<p>RBKC MOE - S1 Comments to be made by RBKC Building Control</p> <p>Kensington & Chelsea TMO</p>			
<p>EMPLOYER'S REQUIREMENTS</p> <p>STUDIO E ARCHITECTS LTD 210 (Brixton) House, 102-100 Upper Street London N1 1UB</p> <p>GREENFELL TOWER REGENERATION PROJECT</p> <p>FIRE STRATEGY</p>			
<p>1:100@A1 24/10/13 JOB: F: DATE: 12/10/13</p>			
<p>12/10/13 101 01 BS DRAWN: CHECKED:</p>

WALKWAY +1 (new resi)
1:100

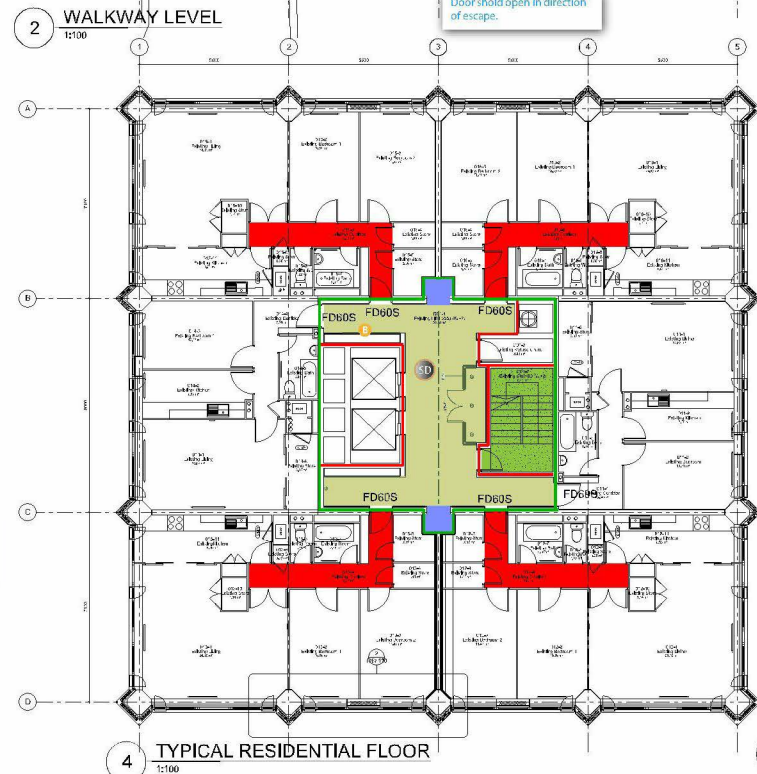
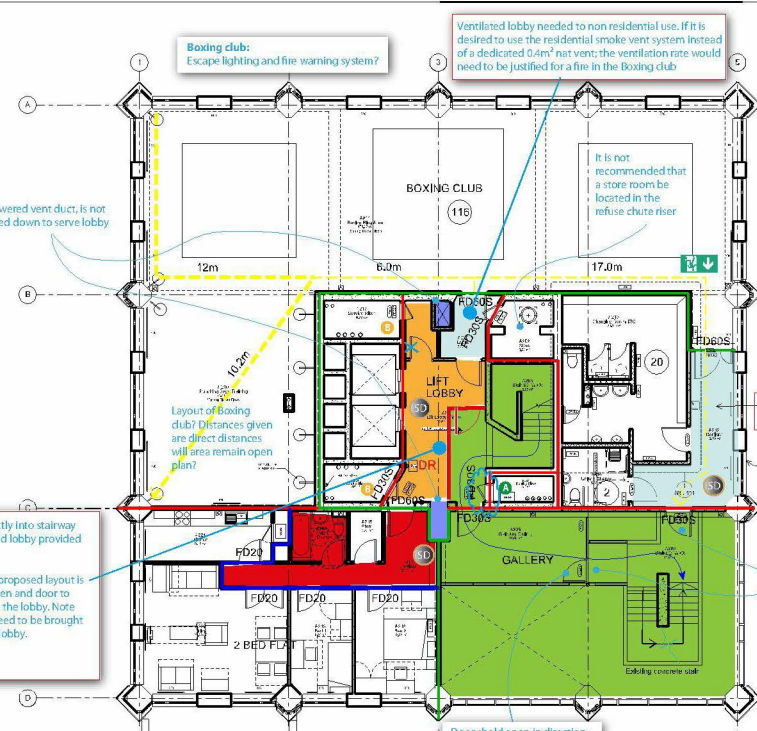
Route of powered vent duct, is not shown carried down to serve lobby

This is a room. Venting the room would not provide the same level of protection as venting a lobby thereto.

Provided that the lift lobby is vented - in this case an additional unvented (red) lobby separation to the residential escape is considered appropriate. The lobby in red should be completed with inner and outer FD30S doors.

FD30S door to complete lobby

Is this space for a wheelchair?

Confirm travel distance is 7.1m as cited if new small ventilation duct can be accommodated with SD as alternative solution

No details of existing extract / supply rates are given therefore no consideration should be given of adverse effect on existing system.
If system designers wish to redesign the system without consideration of adverse effect, justification for the proposed extract rate needs to be submitted, including performance modelling.

Risers accessed from Stairway
Access should not be provided to services from the single stairway.
(Hot and cold water/dry riser services are acceptable in metal pipes with suitable fire stopping). (Note in the existing building these risers were in the lobby). Can these access panels be sealed at this level?

Risers accessed from common Lobbies
Fire resistance should be achieved from the riser side of the enclosure. Access to services from the lobby should be via an FD30S with Fire Door Keep Locked Shut Signage.
